Abutment 2: Overview

Vermont Agency of Transportation
RECEIVED
 CK'D BY _____ OK'D BY Rob Young
 April 21, 2017
 RESUBMIT NO. _____ Approved AsNoted
 BY Rob Young DATE 04/28/2017

| | | SUPERVISOR: E. Barendse DETAILER: I. ADAMS CHECKER: E. Barendse ENGINEER: CONCRETE ENG. SOLUTIONS | PROJ. NAME: HUNTINGTON PROJECT #: BF 0211(32) LOCATION: HUNTINGTON, VT | 04/20/17 | ABUTMENT_2_STEM_OVERVIEW |

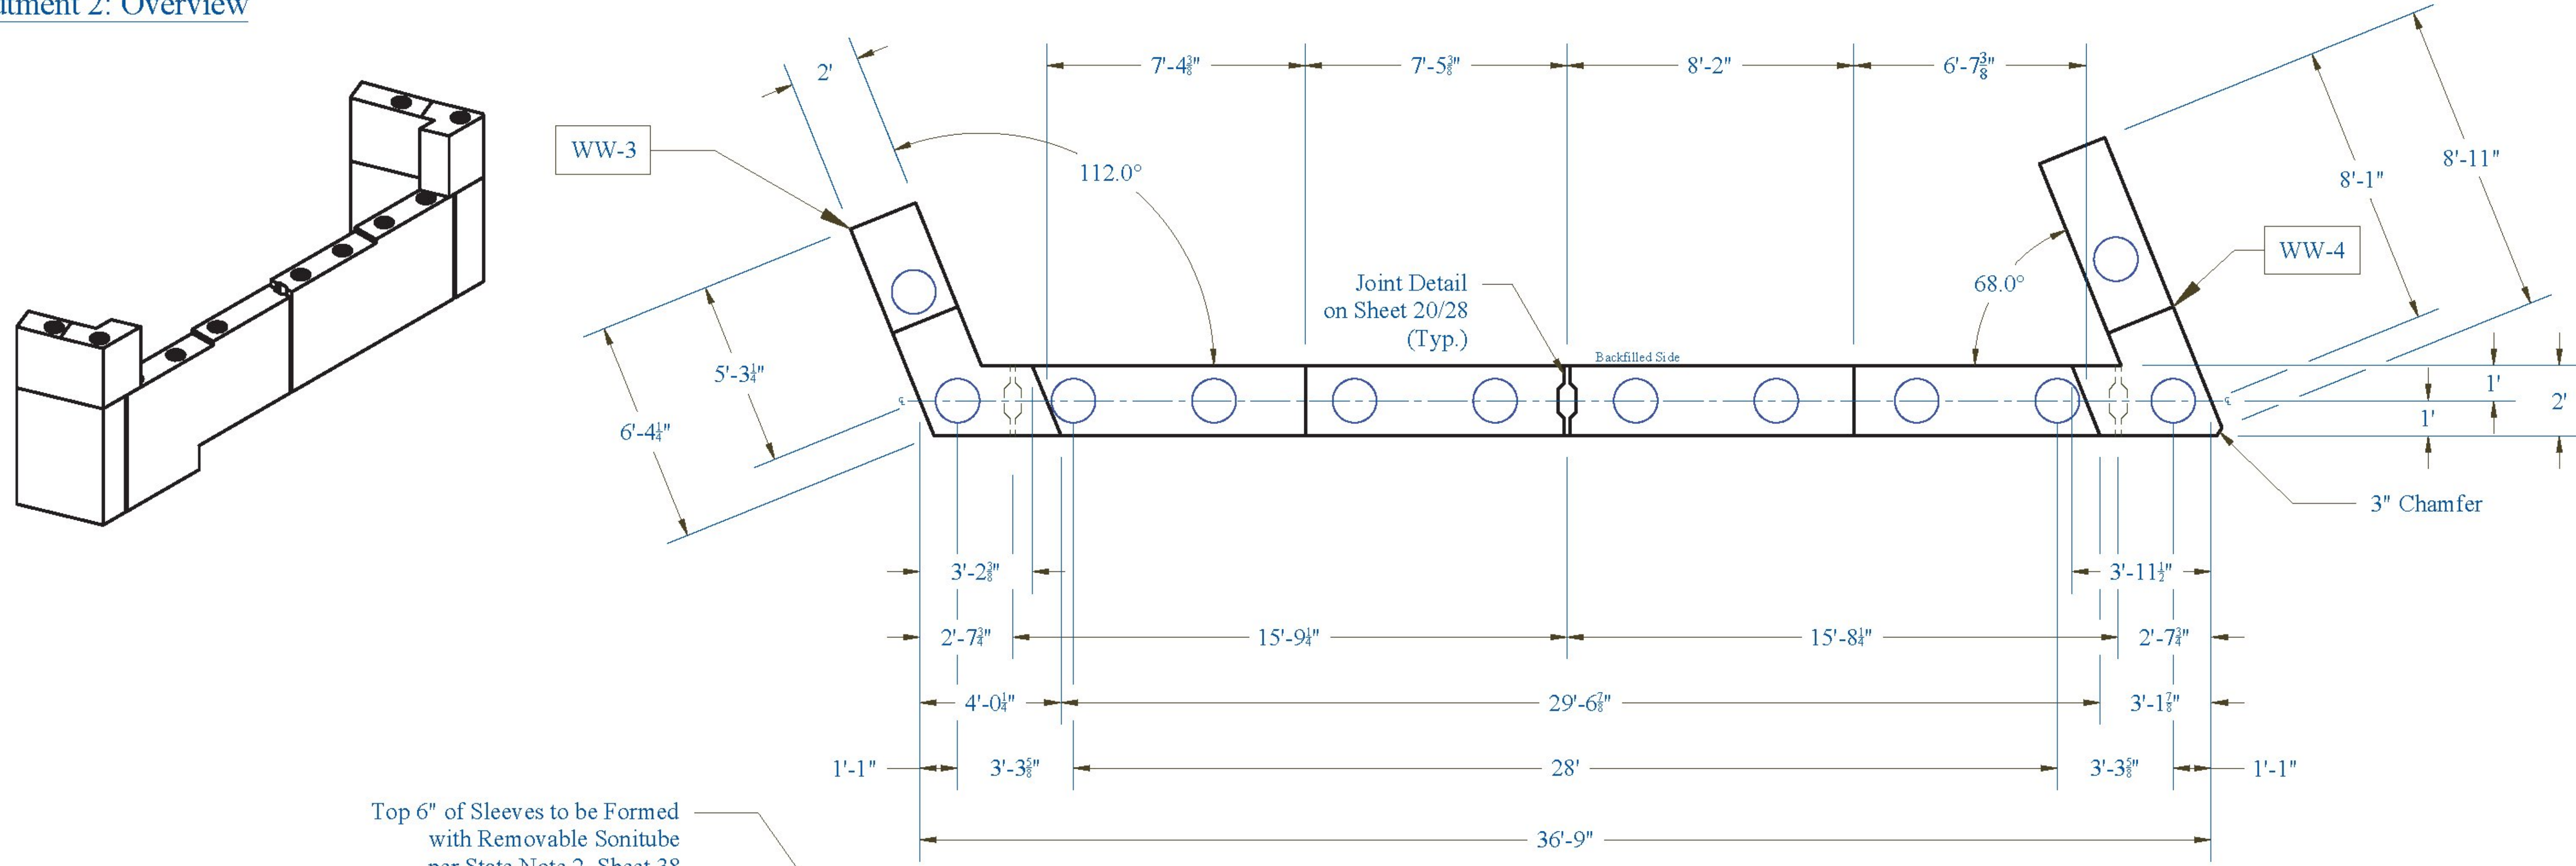
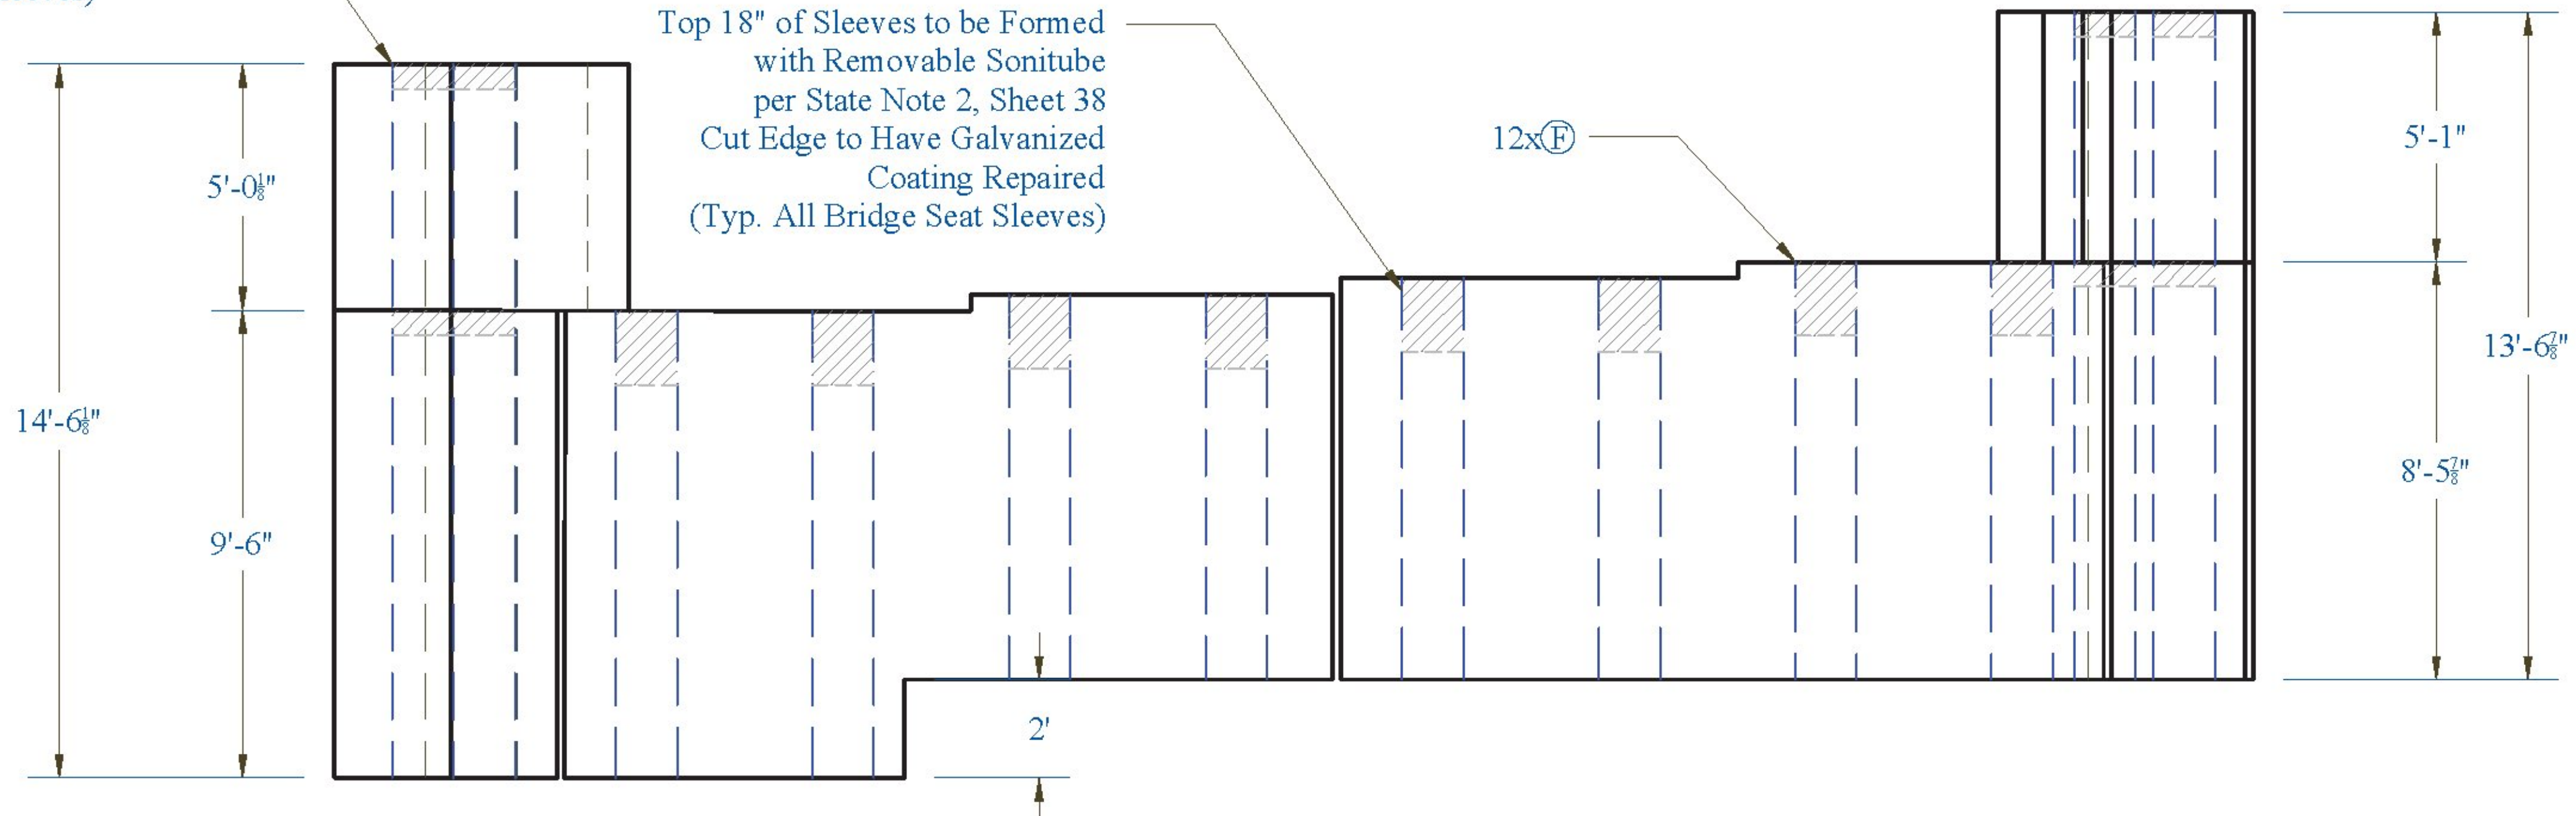
Top 6" of Sleeves to be Formed with Removable Sonitube per State Note 2, Sheet 38 Cut Edge to Have Galvanized Coating Repaired (Typ. All Wing and Cap Sleeves)
